**Addendum #
File # 17-0108**

Project: Park Point Beach House North Wall Replacement

This addendum serves to notify all bidders of the following changes to the solicitation documents:

8 GABLE END DETAIL
1 1/2" = 1'-0"

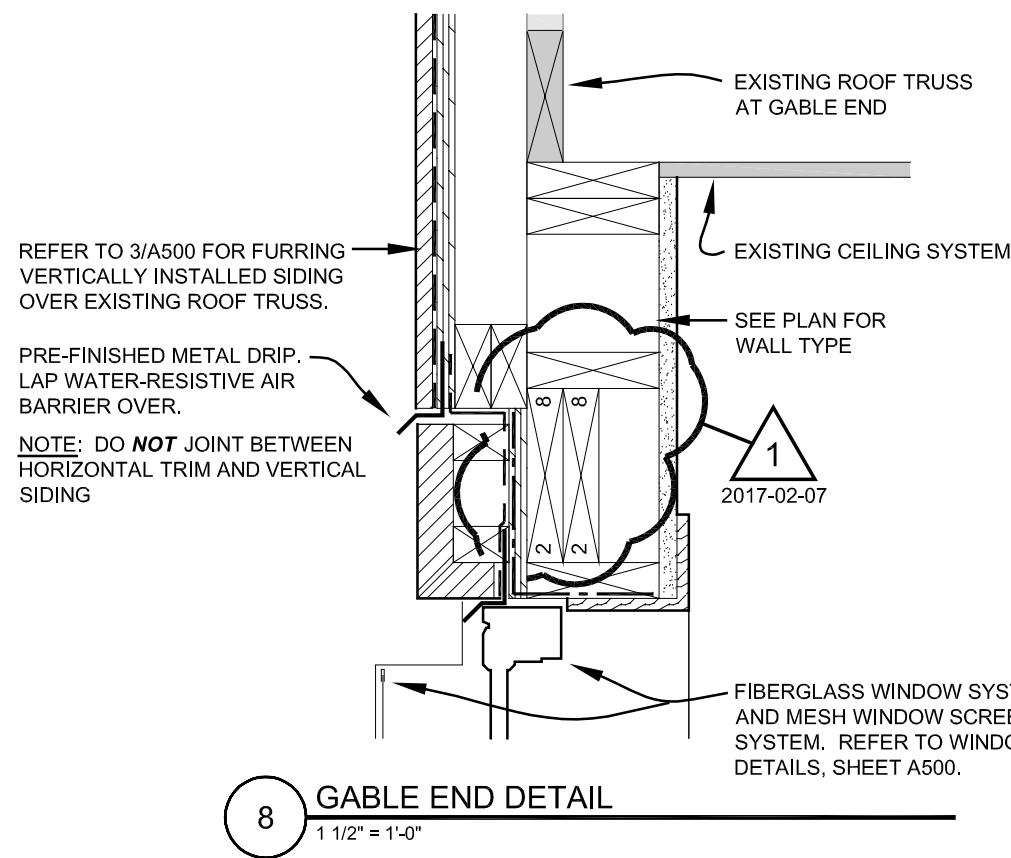
5. Revised Sheet A300 is attached to this Addendum as Exhibit C. Drawing 8 on this sheet shows revised window head framing condition.
6. Revised Sheet A500 is attached to this Addendum as Exhibit D. Drawings 9, 10 and 11 show revised window head framing condition.
